FIGURE 3.2-1

REACTOR COOLANT COLD LEG TEMPERATURE vs. CORE POWER LEVEL

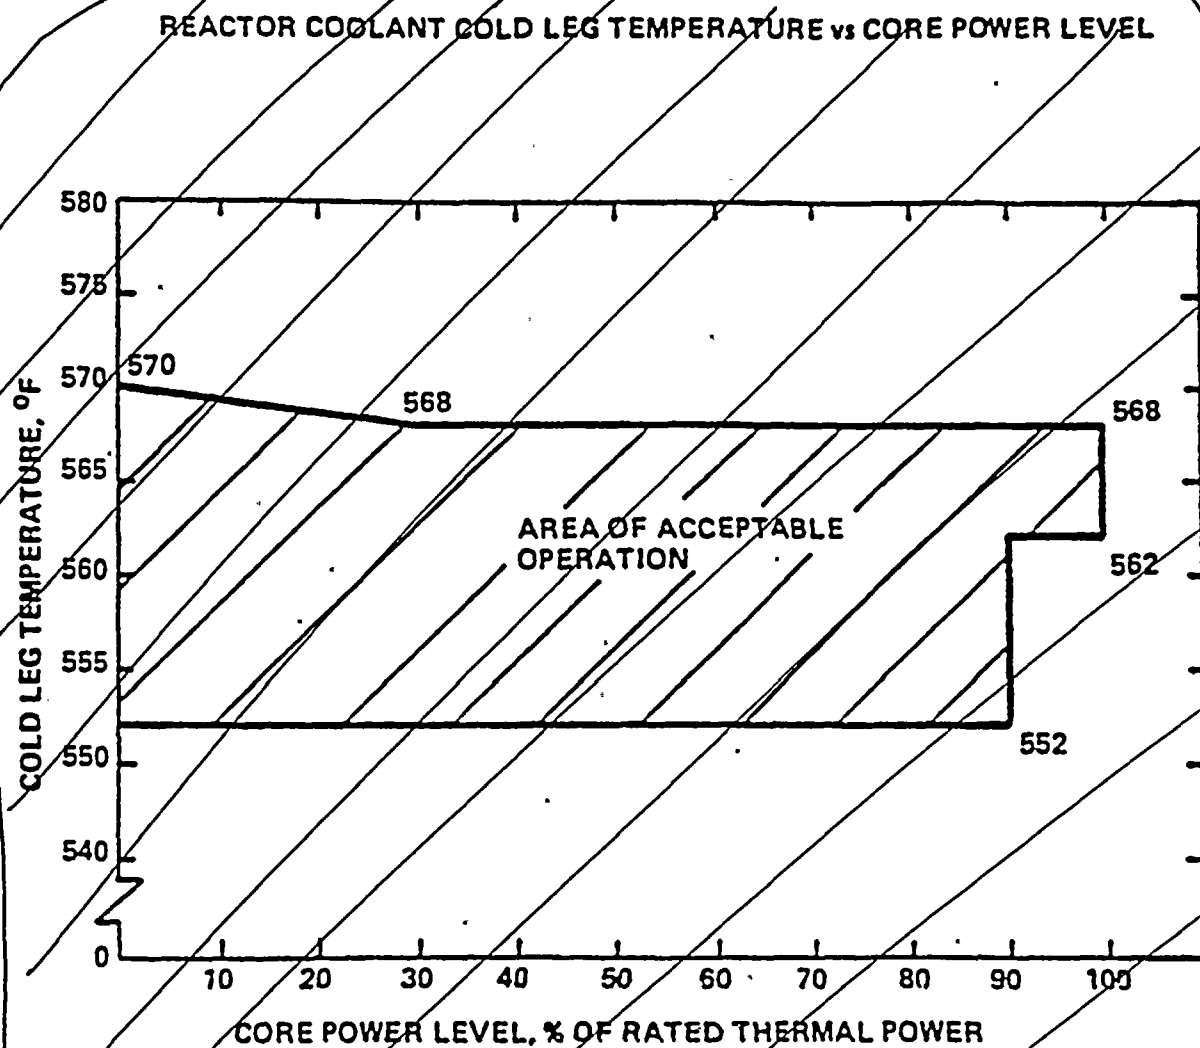
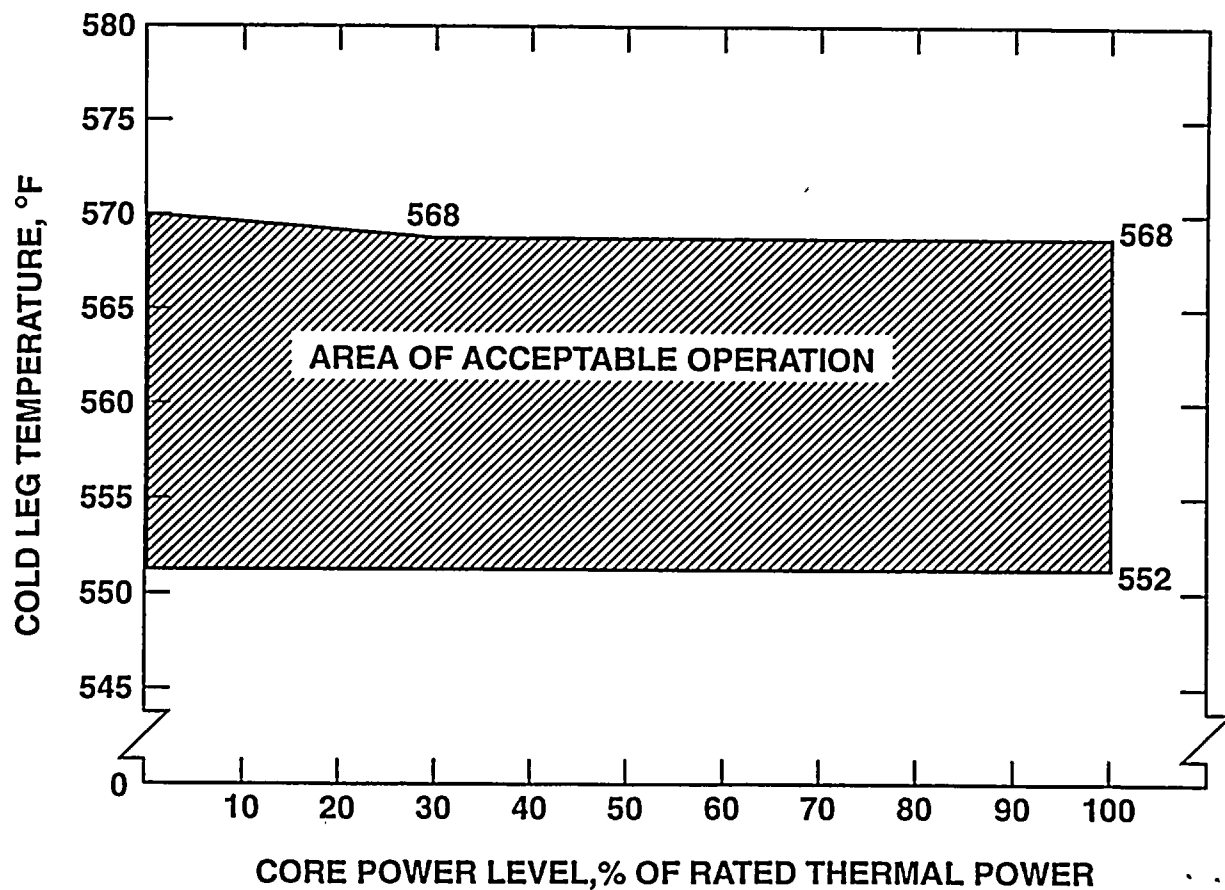
*Replace with Insert A*

Insert A
